PRECAST BENT CAPS

REDFISH BAY AND MORRIS & CUMMINGS CUT BRIDGES

INTENT AND PURPOSE OF SUBSTITUTION

PHASE I ~ PILE CAP PLAN

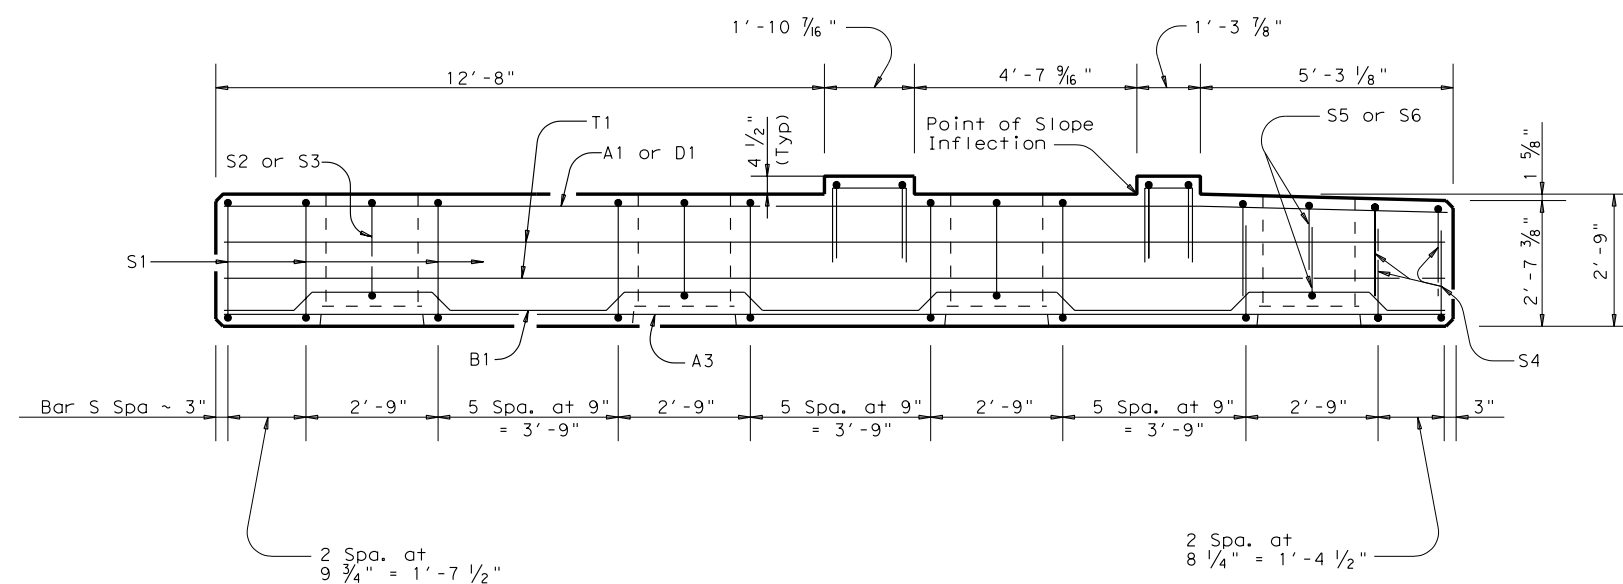
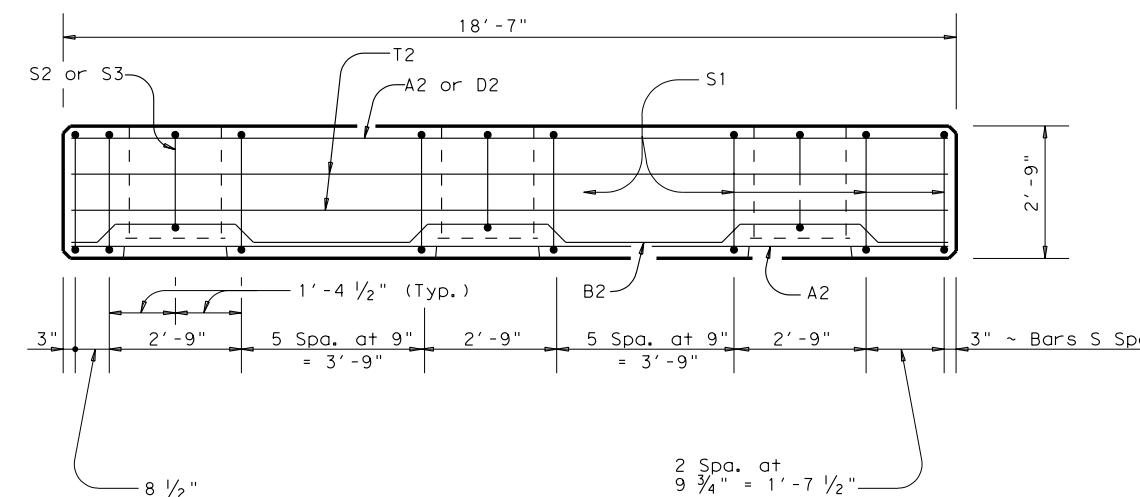
2. Pile Caps ~ Precast Pile Caps shall be provided to replace the cast in place caps set out and detailed on project sheets 34,35, and 47. The precast caps shall match or exceed the structural characteristics of the caps in the project drawings. The caps for the four pile bents supporting Phase I of the construction shall be separate from the caps for the three pile bents supporting Phase II. The caps shall be anchored to the piles. Anchors shall be bound into the pile caps with Portland Cement Concrete which meets or exceeds the strength requirements for concrete for the caps as set out on project sheets 34,35, and 47. The concrete for setting the caps shall also comply with requirements for cement content and shrinkage control as set out in note 3 below.

PLAN OF SLEEVE LOCATIONS IN PILES

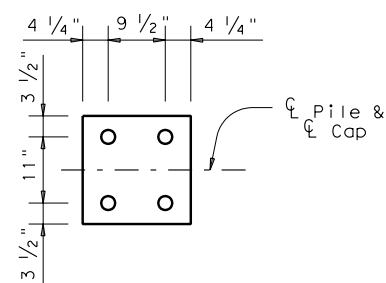
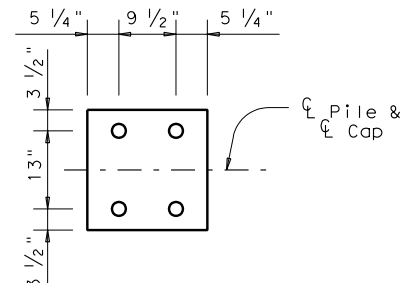
1. Piles ~ Precast, Prestressed Concrete Piles shall conform to requirements set on project sheet no. 61. Each pile in the bridge shall receive 4 - 1 1/2" ϕ x 3'-0" Corrugated Galvanized Steel Sleeves at the locations shown. The sleeves are to provide for installation of Anchor Dowels to caps at each pile. Each leg of dowels shall extend 24 in. into piles, and bonded with epoxy grout. All piles shall be cast with the head of pile chamfer of 2 in. (to eliminate driving impact on the "cover concrete"). Precast pile lengths shall be adjusted to compensate for design embedment of 3" into cap.
